Access Compliance Report

Public Rights-of-Way

Intersection ID: N/A	Main Street: SUGAR_CREEK_RD	Cross Street: N/A	Location: SE
ADA ID: 3E7A470D18D4	Ramp Type: Directional1	Initial Pass/Fail: Pass	Overall Compliance: No
Codes/Mitigation Info/Possible Solution		Field Measurements/Component Compliance	
Severity Score: 15.25

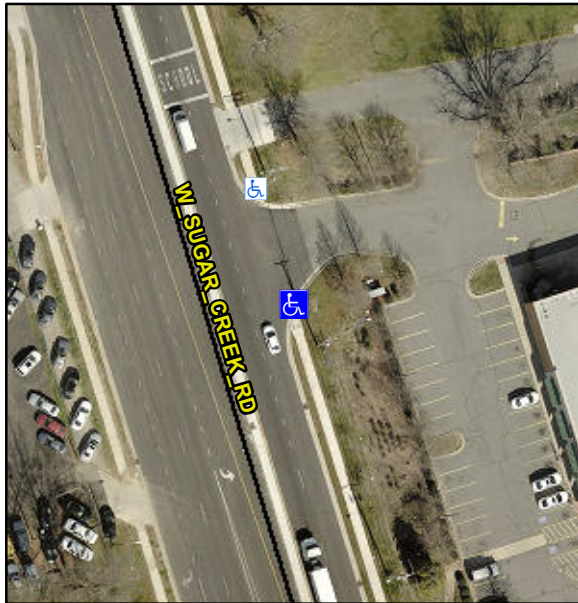
R304.5.3, R305.2, R302.7.2

Compliance	Description	Data	Compliance	Description	Data
N/A	Ramp Length (in)	71.0	Yes	Grade Break?	Yes
Yes	Ramp Width (in)	53.5	Yes	Grade Break Slope (%)	2.3
Yes	Ramp Slope (%)	6.6	No	Grade Break XSlope (%)	3.9
No	Ramp XSlope (%)	4.4			
Yes	Flare Type LT	N/A	Yes	Flare Type RT	N/A
N/A	Flare Slope LT (%)	N/A	N/A	Flare Slope RT (%)	N/A
N/A	Flare Traversable LT?	No	N/A	Flare Traversable RT?	No
Yes	Landing Length (in)	60.0	Yes	DWS Provided?	Yes
Yes	Landing Width (in)	57.5	Yes	DWS Contrast?	Yes
Yes	Landing Slope (%)	1.9	Yes	DWS Length (in)	24.0
Yes	Landing X Slope (%)	1.8	Yes	DWS Full Width?	Yes
N/A	Landing Curb? (Y/N)	N/A	No	DWS Offset LT (in)	91.0
N/A	Shared Landing?	No	No	DWS Offset RT (in)	3.0
Yes	Gutter Ponding?	No	Yes	Gutter Slope (%)	1.3
No	Gutter Lip Ht (in)	1.5	Yes	Gutter X Slope (%)	1.5
N/A	Painted X Walk1?	No		Road Slope (%)	3.1
	X Walk 1 Direction	To NW		Road X Slope (%)	1.5
	X Walk 1 Width (in)	N/A		Clear Space?	Yes

X Walk 1 Slope (%)	3.1	N/A	Clear Space to XWalk (in)	N/A
	X Walk 1 X Slope (%)	1.5	Yes	Storm Grate/Utility Hazard?	No
N/A	Ramp inside XWalk1?	N/A		Storm Grate/Utility Type	
Yes	Any Obstructions?	No			N/A
	Obstruction Type		Yes	Surface Condition? (G/P)	Good
			N/A	Curb Slope (%)	10.1

**Remove & Replace Entire Ramp.
Grind Gutter Lip.**
